FSC Report ABP-318860-24

Appeal v Condition (No.3)

Revised FSC for a Proposed
Residential Development at
Drummartin Link Road, Kilmacud
Road Upper, Dublin 14.

FRV2306518DR

Figure 12 — Common escape routes in single stair buildings more than 11 m in height

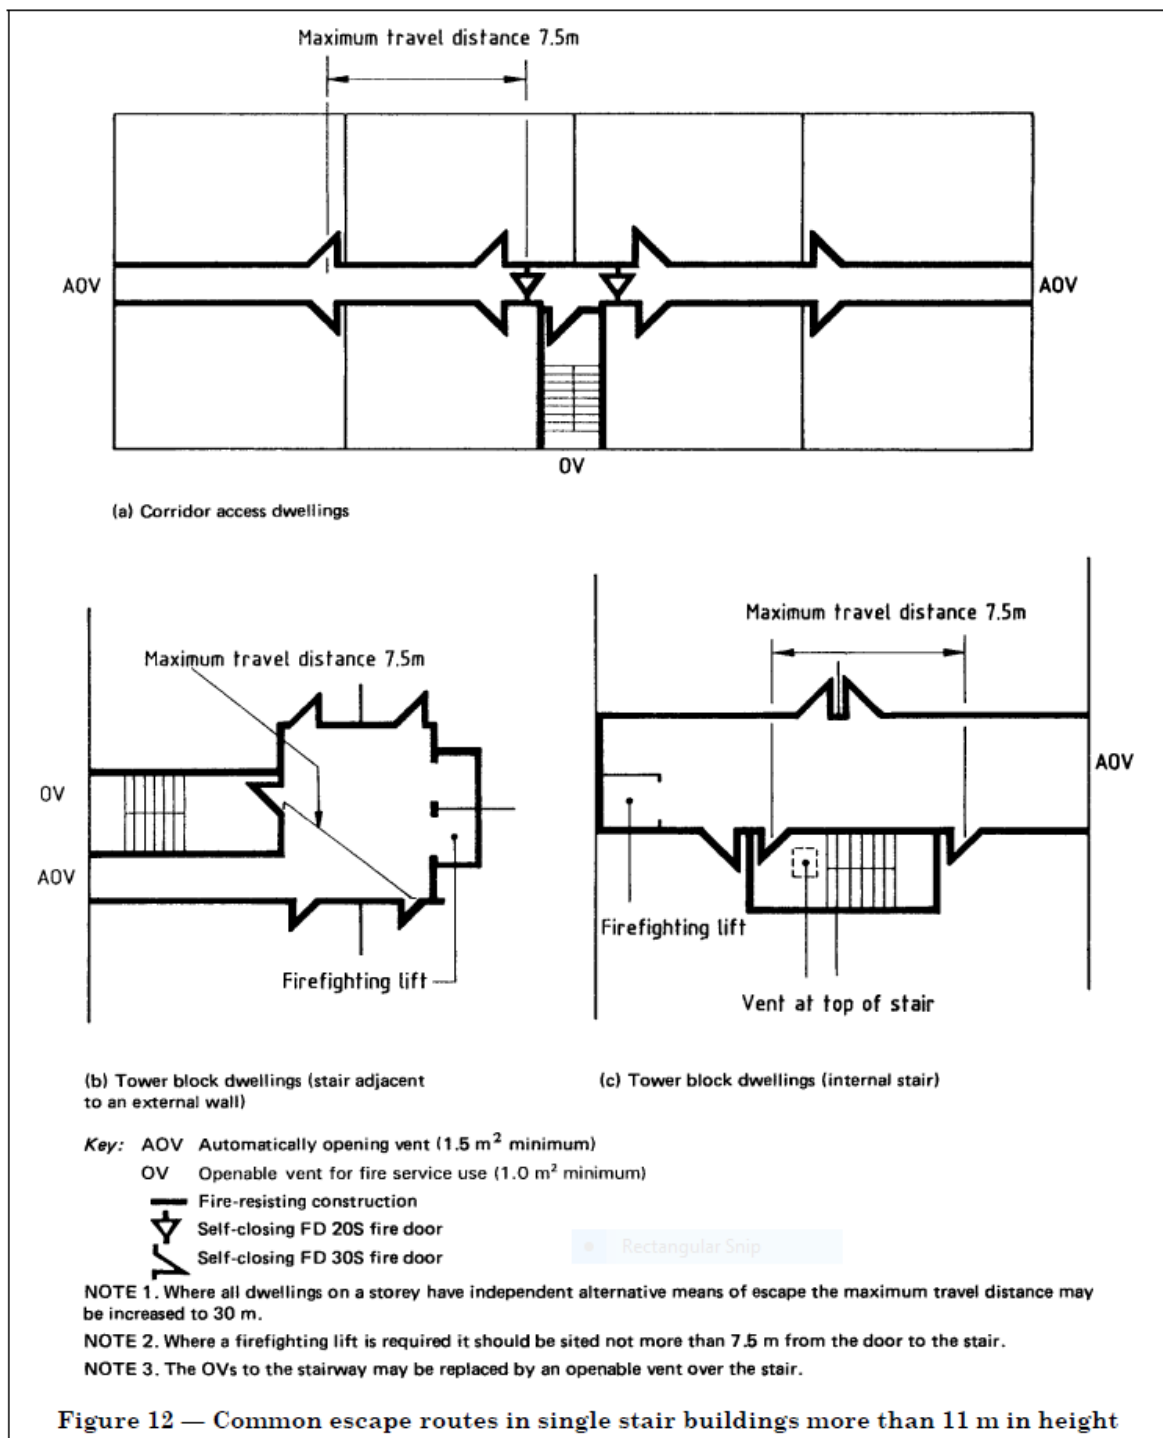
- 6.2.5. It is my interpretation that Paragraph 12 and Figure 12 of the BS (REF: Appendix A) requires the provision of AOVs in all scenarios to protect “Common escape routes in single stair buildings more than 11m in height”. It is my interpretation that Diagram 13, is only relevant for design of “Common escape routes in multi-stair buildings” and is therefore not relevant here as this part of the building is only served by a single stair (Stair 01).

- 6.2.7. I believe the BCA to be reasonable in looking for the provision of AOVs to the corridors accessing the apartments (including the corridor accessing Apartments 06 & 07) to provide protection to Stair 01 as they have adequately demonstrated that this is a requirement of TGD Part B 2006 (Reprint 2020).
